## PLAN REVIEW SHEET

| <b>Petition:</b>         | 2008-031   | <b>Fax:</b>           | 704-432-1277   |
| <b>Location:</b>         | Approx. 116.30 acres on NE<br>Quadrant of Brookshire Blvd./<br>I-485 Interchange   | <b>Attachments:</b>   | Shelter_Concrete_Standards.pdf<br>(See 60.03A)                                 |
| <b>Requested Zoning:</b> | B-D(CD) S.P.A. (LWPA) &<br>NS S.P.A. (LWPA)<br>(To accommodate several<br>modifications to the site plan for the<br>previously approved ped-oriented<br>multi-use development) |                       |  |

| STD. NO. | REV. |
|----------|------|
| 60.03A   |      |

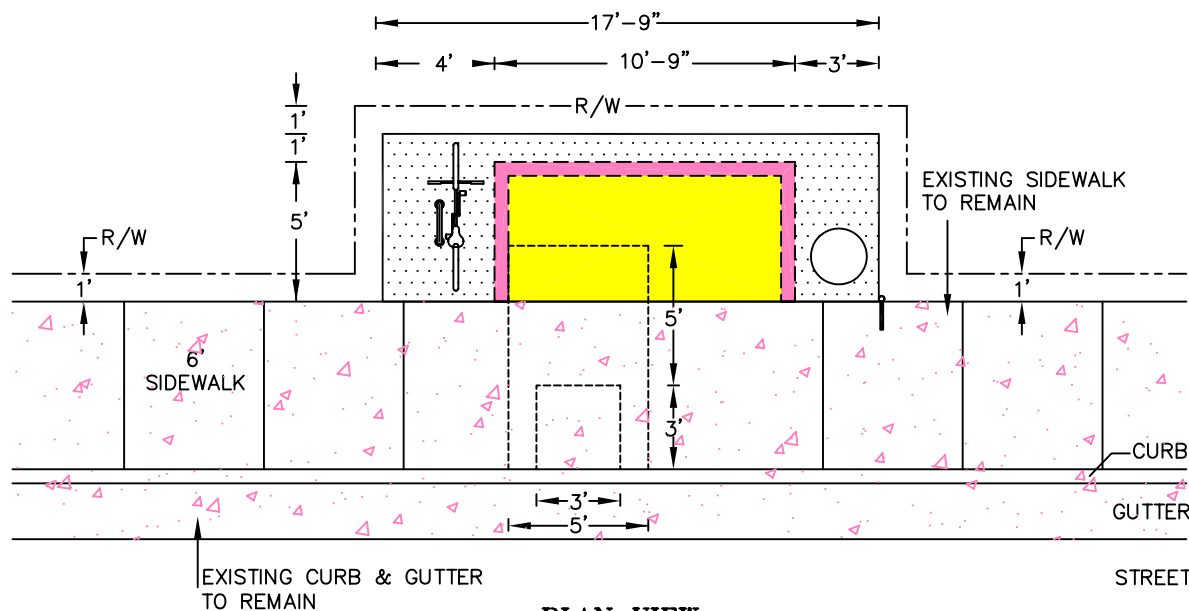
- 2) **CATS additionally requests the petitioner to construct a shelter pad constructed to CATS Development Standards 60.03 A (see attached).**
  - The shelter pad should be constructed at least 60' from the intersection of Street 1 (public) and Street 5 (private), along Street 5 (private) with direct and accessible access to the 50 non-exclusive CATS Park and Ride spaces.
